PLANNING, ZONING, & BUILDING DEPARTMENT
PZ&B Staff Memorandum: Architectural Commission

SUBJECT: ARC-24-0096 150 WORTH AVE

MEETING: JANUARY 29, 2025, ARCOM

ARC-24-0096 150 WORTH AVE—THE ESPLANADE. The applicant, Wilson 150 Worth LLC, has filed an application requesting Architectural Commission review and approval for updated paving, updated railings, removal of the main central staircase, and the addition of a water feature for the Esplanade.

2. Decorative Area Drain | Proposed Pattern Options

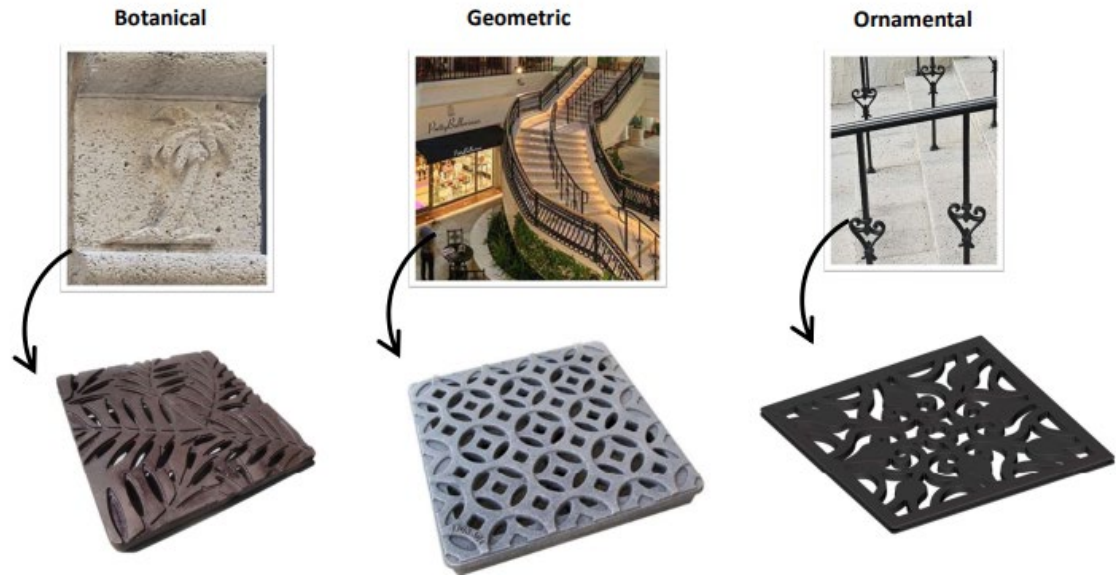
The applicant is proposing to refresh the interior courtyard of the Esplanade shopping area. This includes a change in paver material. The proposed material is coral stone with accent tiles that could be in the Versailles diamond, Calçada Portuguesa or Dijon set of San Filippino tile pattern.

This would include installation of additional drainage areas concealed with drain covers.

All drains would be constructed of dark oil-rubbed bronze, options below to be reviewed for pattern only

1. Decorative Tile | Proposed

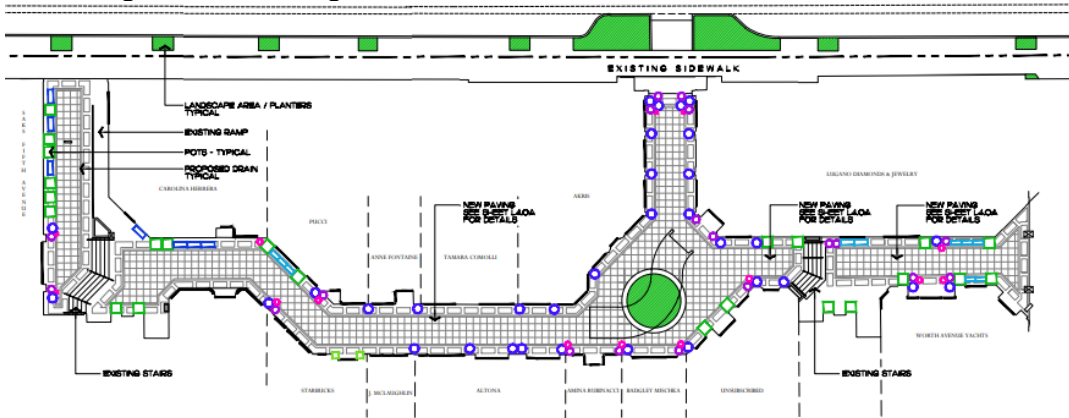
The second most visible change will be tiles on the stair risers. The applicant is bringing forth several options for ARCOM to consider:

1. Custom hand-painted Mizner tiles sized to fit within final step risers
2. Referencing original tile motif with central fleurette and corner detailing
3. Esplanade color palette matching
4. Riser Patterning Options:
 - a. Same tile throughout
 - b. Alternating per riser
 - c. Alternating per tread and riser
